Introduction to the Study Version of the Racing Rules for 2017-2020

This document is a ‘Study Version of the Racing Rules for 2017-2020.’ This is a special document designed to provide you with the reasons for each change in the Definitions and in the rules of Parts 1 – 7 in the 2017 rulebook.

Submission 175-15

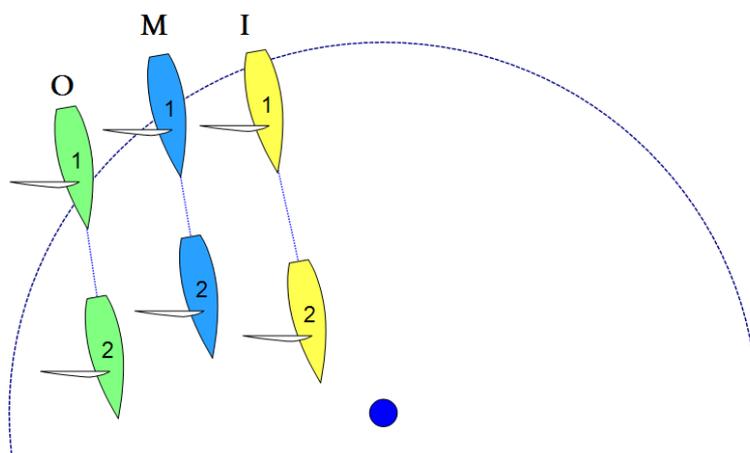
Over the past year, competitors and judges have noticed that there are several problematic situations in which both rule 19.2(b) and rule 18.2 apply at the same time. In all of them, there is no need for rule 19.2(b), and it complicates the analysis of the situations and may result in unfair outcomes that were unintended when the Section C rules were written.

The diagram below shows one example of such a problematic situation. This is a situation that occurs frequently in fleet racing. Rule 18.2 covers the situation adequately. There is no need for rule 19.2(b) to apply and it can lead to unintended consequences. For example, if O does not give I sufficient space for I to give M room as required by rule 19.2(b), then, to avoid penalization under rule 19.2(b), I must pass the mark on the wrong side. If I fails to do so, no current rule will exonerate her for breaking rule 19.2(b). Under proposed rule 19.1(b), however, rule 19.2(b) would not apply and, therefore I would not be required to pass the mark on the wrong side. Rule 18.2(b) would apply and I would be exonerated under rule 21 if she broke either rule 11 with respect to M or rule 31 by touching the mark.

The mark is a leeward mark to be left to port with the next leg to windward.
 Under the current rules:
 (1) Rule 18.2(b) requires M to give mark-room to I.
 (2) Rule 18.2(b) requires O to give mark-room to M and I.
 (3) Rule 19.2(b) requires I to give room to M to pass between her and O.
